Edbro Trailer Inclinometer TINC01/12v & 24V

Cable wiring colours have changed in kits manufactured from January 2015.

TRACTOR SUZI CONNECTOR

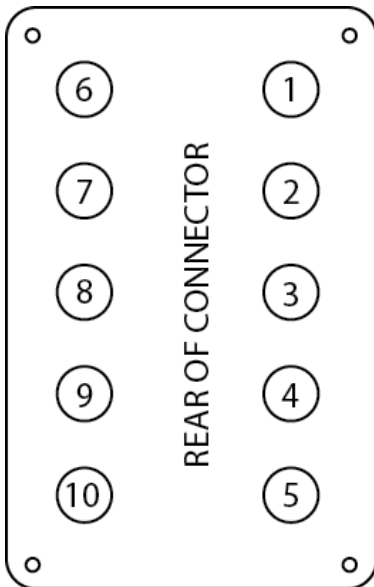
2015 onwards	Before 2015
Serial# \geq 011501	Serial# \leq 121401
1. BLACK (0v sensor & sounder)	1. BLACK (0v sensor & sounder)
2. BROWN (sensor)	2. BROWN (sensor)
3. GREEN (sensor ground)	3. GREEN (sensor ground)
4. NOT USED	4. White (sensor buzzer signal)
5. RED (+v supply to sensor)	5. RED (+v supply to sensor)
6. SCREEN	6. SCREEN
7. WHITE (Ext sounder trigger +24v when sounding)	7. Grey (Ext sounder trigger +24v when sounding)
8. NOT USED	8. NOT USED
9. NOT USED	9. NOT USED
10. NOT USED	10. NOT USED

Note: Internal sensor buzzer signal no longer used on 2015 versions

TRAILER SUZI CONNECTOR

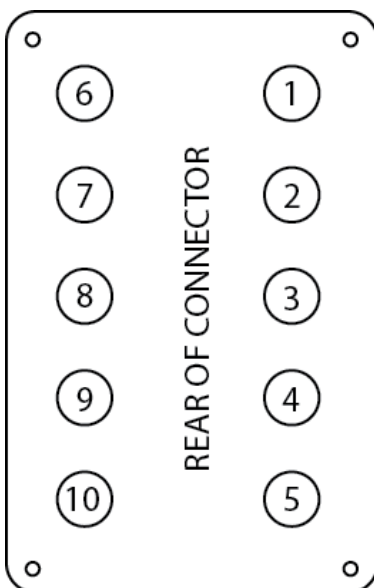
2015 onwards	Before 2015
Serial# \geq 011501	Serial# \leq 121401
1. BLACK + BLACK FROM SOUNDER (0v for sensor & sounder)	1. BLACK + BLUE FROM SOUNDER (0v for sensor & sounder)
2. BROWN (sensor output)	2. BROWN (sensor output)
3. GREEN (sensor ground)	3. GREEN (sensor ground)
4. NOT USED	4. WHITE (sensor buzzer signal)
5. RED (+v supply to sensor)	5. RED (+v supply to sensor)
6. SCREEN	6. SCREEN
7. RED FROM SOUNDER (Ext sounder trigger +24v when sounding)	7. BROWN FROM sounder (Ext sounder trigger +24v when sounding)
8. NOT USED	8. NOT USED
9. NOT USED	9. NOT USED
10. NOT USED	10. NOT USED
